Addendum #2
Solicitation 22-99784
City Hall Grounds Improvements

This addendum serves to notify all bidders of the following changes to the solicitation documents:

**DULUTH CITY HALL
 LANDSCAPE IMPROVEMENTS**
 CITY OF DULUTH, MINNESOTA

SHEET TITLE
**LANDSCAPE EXISTING
 CONDITIONS & REMOVALS**
 DATE: FEB. 2023
 DRAWN BY: LWS
 CHECKED BY: LWS
 PROJECT NUMBER
 21120
 SHEET NUMBER
 L4.1

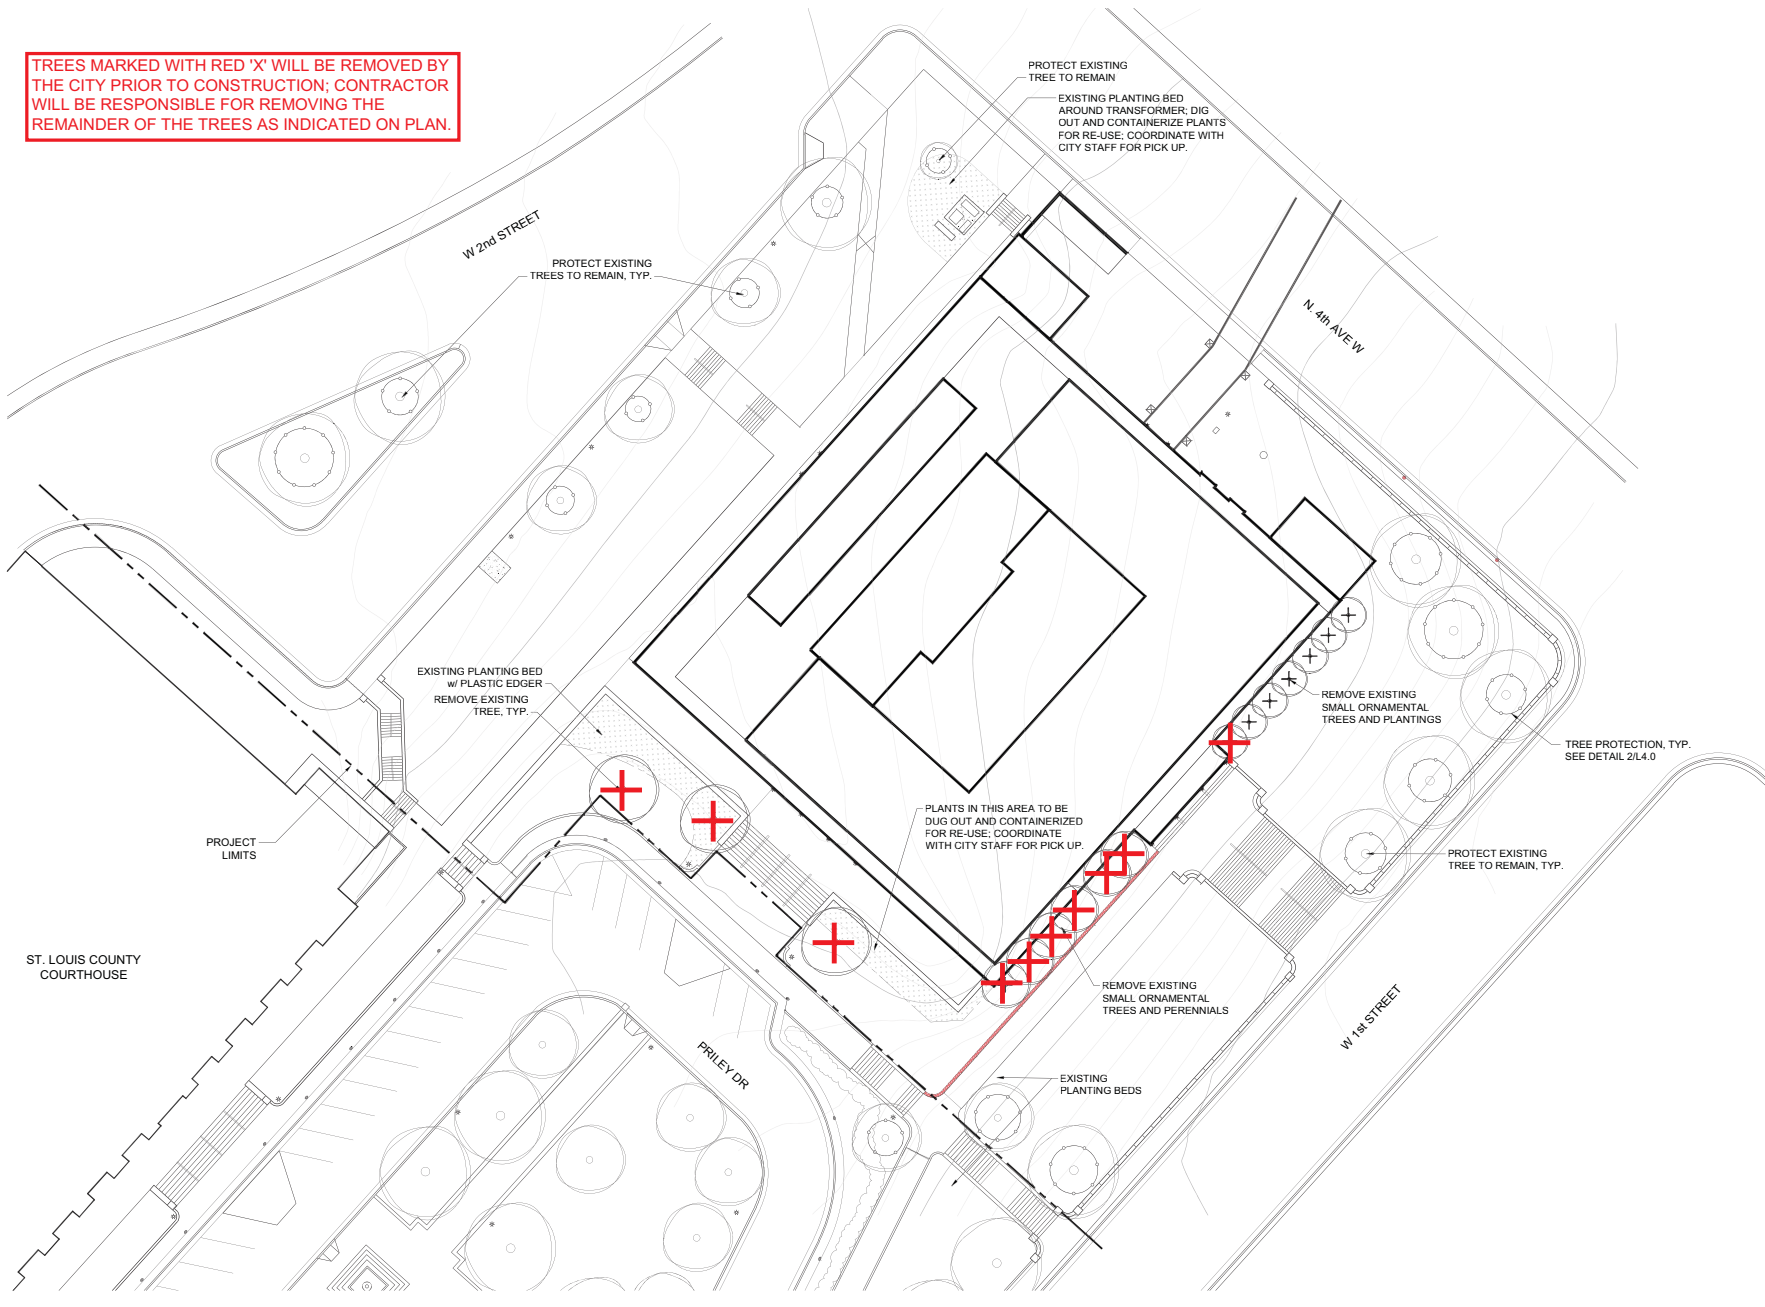
1. The pre-bid meeting sign-in sheet is attached.
2. Tree Removal: see attached Sheet L4.1 for clarification on tree removals.
3. The following questions asked are answered below in red italics:

Sheet L4.1-Landscape Existing Conditions & Removals; See clarification on which trees Contractor will be responsible for removing (attachment identifies trees that will be removed by the City Prior to project commencement).

TREES MARKED WITH RED 'X' WILL BE REMOVED BY THE CITY PRIOR TO CONSTRUCTION; CONTRACTOR WILL BE RESPONSIBLE FOR REMOVING THE REMAINDER OF THE TREES AS INDICATED ON PLAN.

3 CONCRETE DRIVE AT BUILDING SLAB
SCALE: NOT TO SCALE

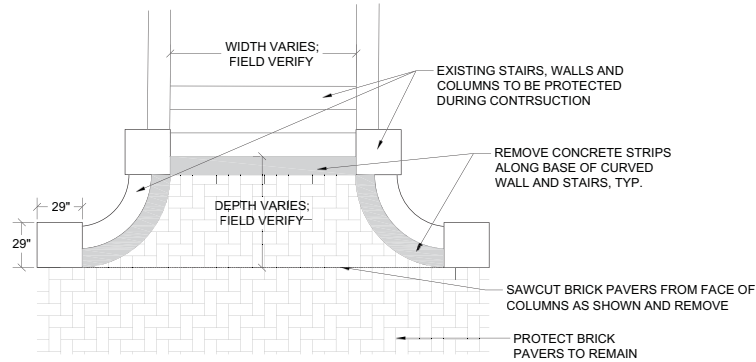
- 2) Bid Item #6: Geo-Textile Fabric: What Items does this include? *To be used at base of stairs in stair repairs.*
 - 3) Bid Item #9: Concrete Drive Paving-Two different sizes are specified: 6" per L1-4 (Detail 3) or 8" per L1.2 (Detail 5) *Concrete sidewalks/driveways around parking lot and in service drive area are to be 8", interior sidewalks are to be 6". See attached revised detail 3/L1.4 for clarification.*

Sheet L1.4-Ste Details; See revised Detail 3.
